Access Compliance Report

Public Rights-of-Way

(Curb Ramps)

Intersection ID: 42643	Main Street: E_3RD_ST	Cross Street: E_JOHN_BELK_RA	Location: SE
ADA ID: 98D5C910D5E5	Ramp Type: Directional2	Initial Pass/Fail: Fail	Overall Compliance: No
Severity Score: 37.5			
Codes/Mitigation Info/Possible Solution		Field Measurements/Component Compliance

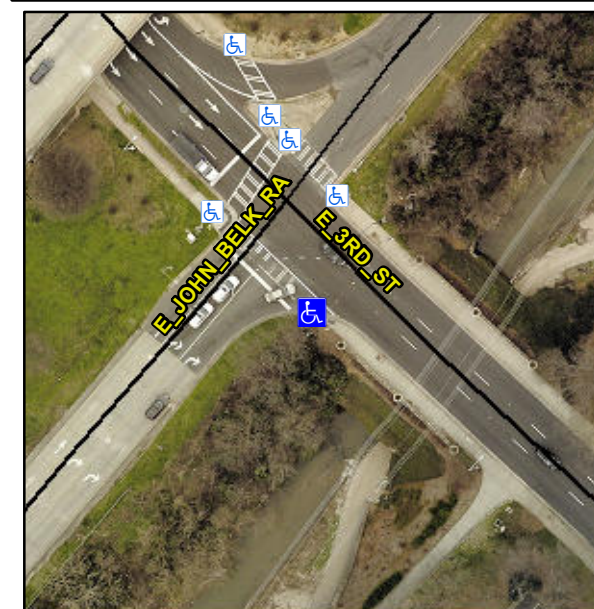
R304.2.2, R304.5.3

Compliance	Description	Data	Compliance	Description	Data
N/A	Ramp Length (in)	72.0	N/A	Grade Break?	N/A
Yes	Ramp Width (in)	84.0	N/A	Grade Break Slope (%)	0.0
No	Ramp Slope (%)	8.8	N/A	Grade Break XSlope (%)	0.0
No	Ramp XSlope (%)	7.1			
N/A	Flare Type LT	N/A	N/A	Flare Type RT	N/A
N/A	Flare Slope LT (%)	N/A	N/A	Flare Slope RT (%)	0.0
N/A	Flare Traversable LT?	N/A	N/A	Flare Traversable RT?	N/A
N/A	Landing Length (in)	0.0	N/A	DWS Provided?	N/A
N/A	Landing Width (in)	0.0	N/A	DWS Contrast?	N/A
N/A	Landing Slope (%)	0.0	N/A	DWS Length (in)	N/A
N/A	Landing X Slope (%)	0.0	N/A	DWS Full Width?	N/A
N/A	Landing Curb? (Y/N)	N/A	N/A	DWS Offset LT (in)	N/A
N/A	Shared Landing?	N/A	N/A	DWS Offset RT (in)	N/A
N/A	Gutter Ponding?	0.0	N/A	Gutter Slope (%)	N/A
N/A	Gutter Lip Ht (in)	0.0	N/A	Gutter X Slope (%)	N/A
N/A	Painted X Walk1?	Yes		Road Slope (%)	1.2
	X Walk 1 Direction	To NW		Road X Slope (%)	8.9
	X Walk 1 Width (in)	109.0		Clear Space?	N/A

X Walk 1 Slope (%)	1.2	N/A	Clear Space to XWalk (in)	N/A
	X Walk 1 X Slope (%)	8.9	N/A	Storm Grate/Utility Hazard?	N/A
N/A	Ramp inside XWalk1?	Yes		Storm Grate/Utility Type	
N/A	Any Obstructions?	N/A			N/A
	Obstruction Type		Yes	Surface Condition? (G/P)	Good
			N/A	Curb Slope (%)	22.2

Remove & Replace Entire Ramp.
